Alter flight operations to as high an altitude as possible and safe
MC3 Recommendation 1A

Alter helicopter routes from west along 22nd Street to I-10
MC3 Recommendation 1C

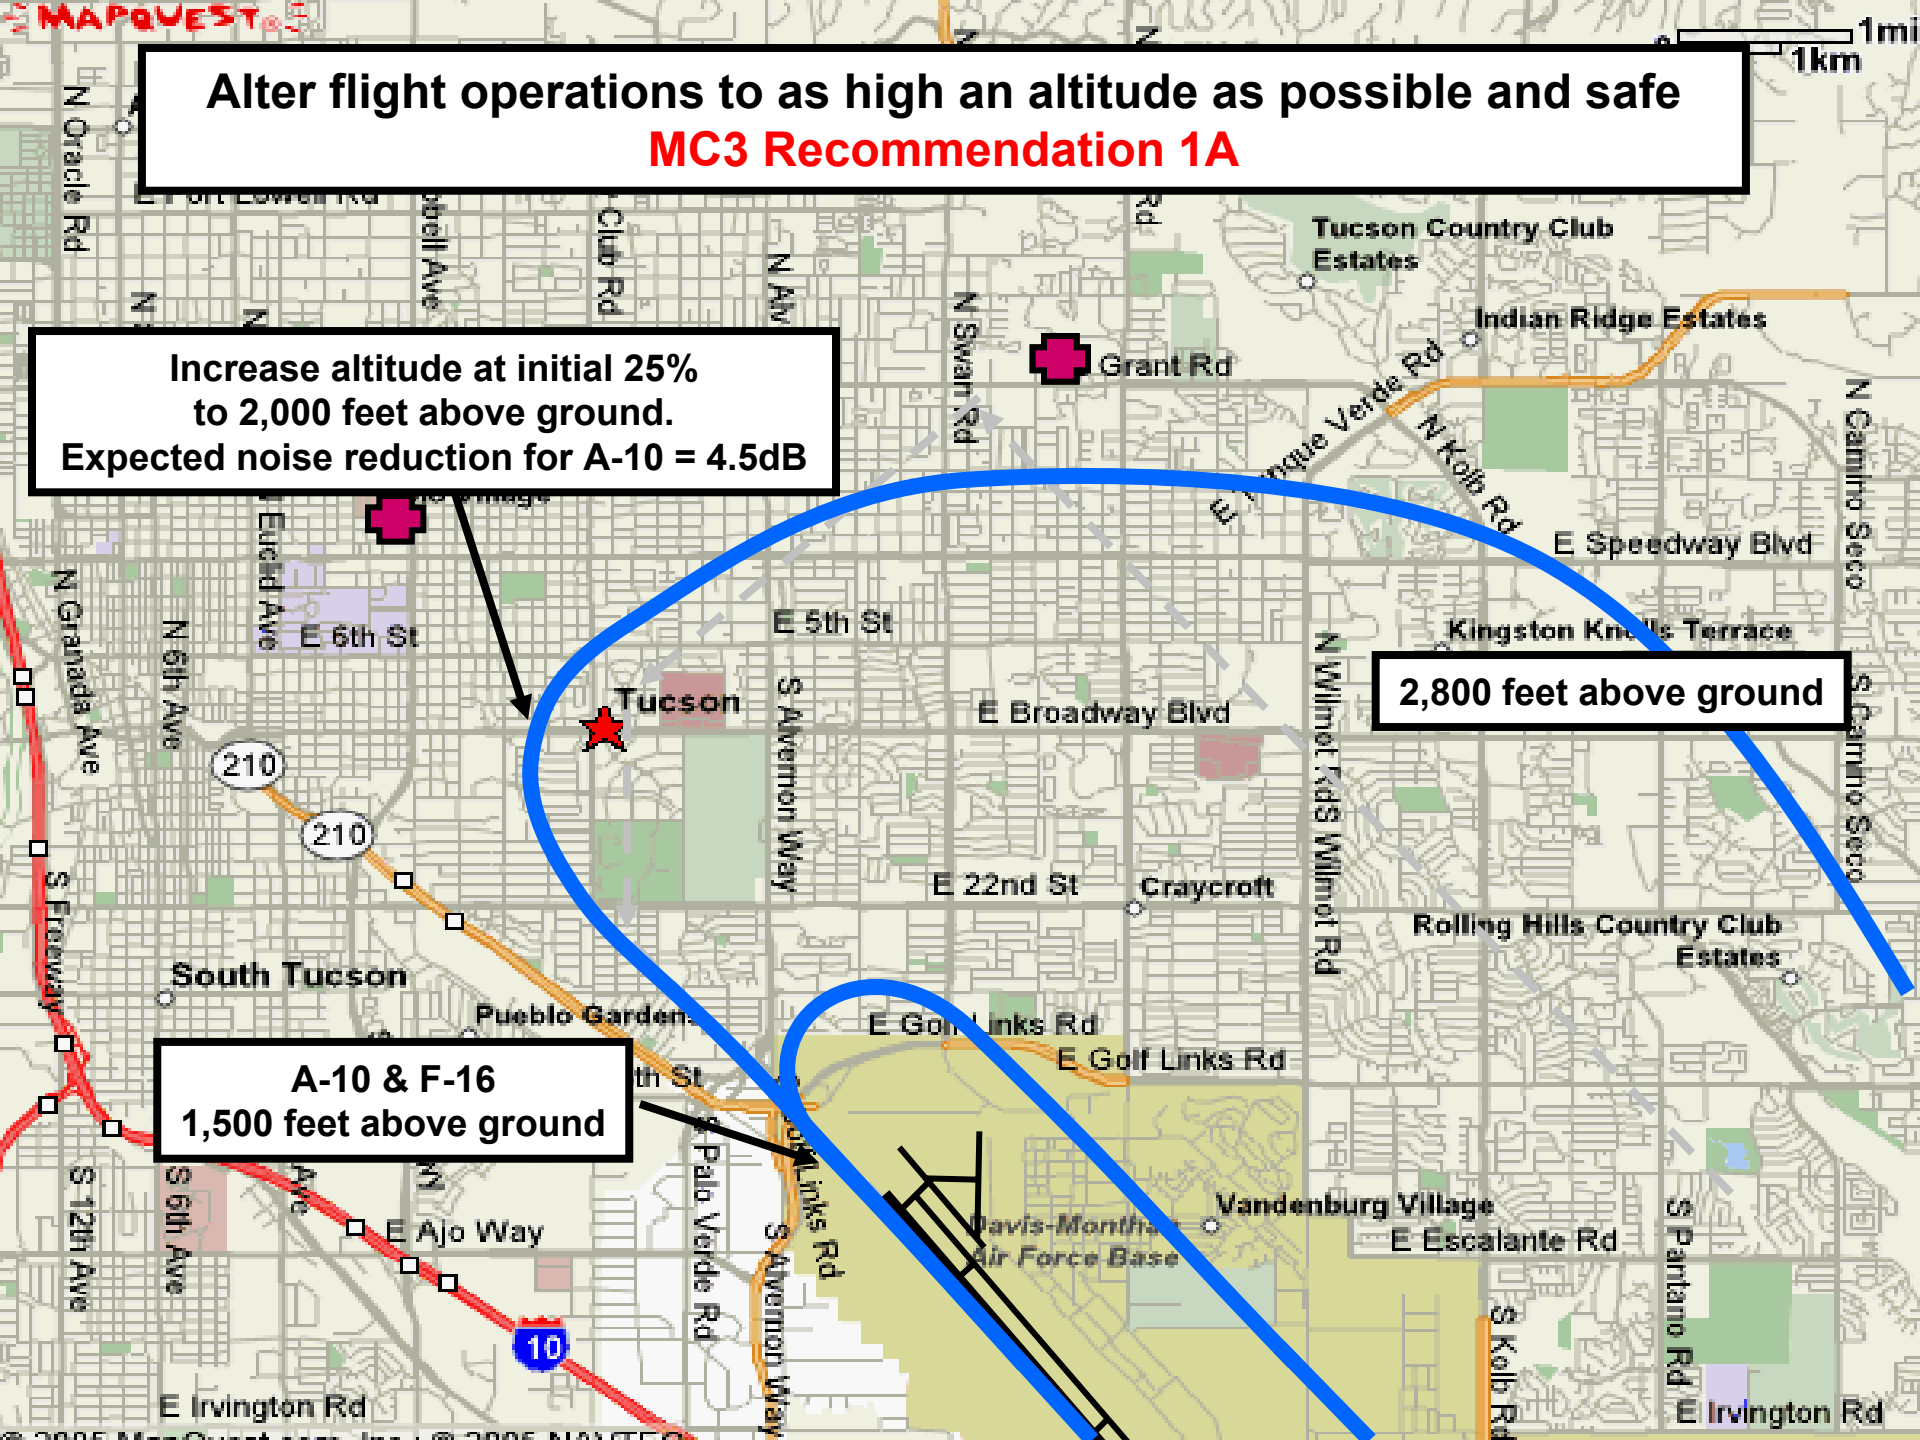
**Increase altitude at initial 25%
to 2,000 feet above ground.**
Expected noise reduction for A-10 = 4.5dB

Change 1
Alter departure southwest to I-10 then northwest to I-10 and 22nd avoiding residential areas northwest of the base

Change 2
Increased altitude 60% to 800 feet above ground. Noise reduction: ~3.4dB
